Atari Tech Tip Xevious™

Symptoms: Timing problems that may cause reset, lock-up, sound failures, video jumping or flashing.

Figure 1 CPU Board Reset Modifications

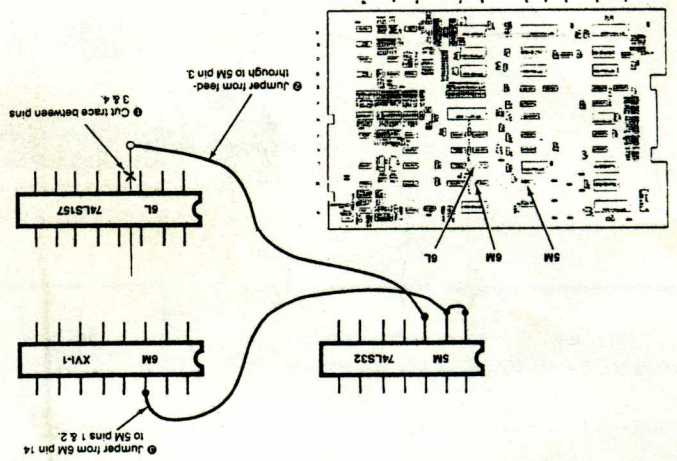
On CPU Board (Refer to Figure 1)

1. On component side, cut trace between 6L pins 3 and 4.
2. Connect feedthrough of cut trace to 5M pin 3.
3. Connect 6M pin 14 to 5M pins 1 and 2.
4. Connect 6M pin 14 to 5M pins 1 and 2.

Modified video boards should only be paired with modified CPU Boards.

The modification to the CPU board is for resetting or lock-up problems. The CPU modification affects the timing on the video board. Therefore, if the CPU modification is done, the video changes are also necessary.
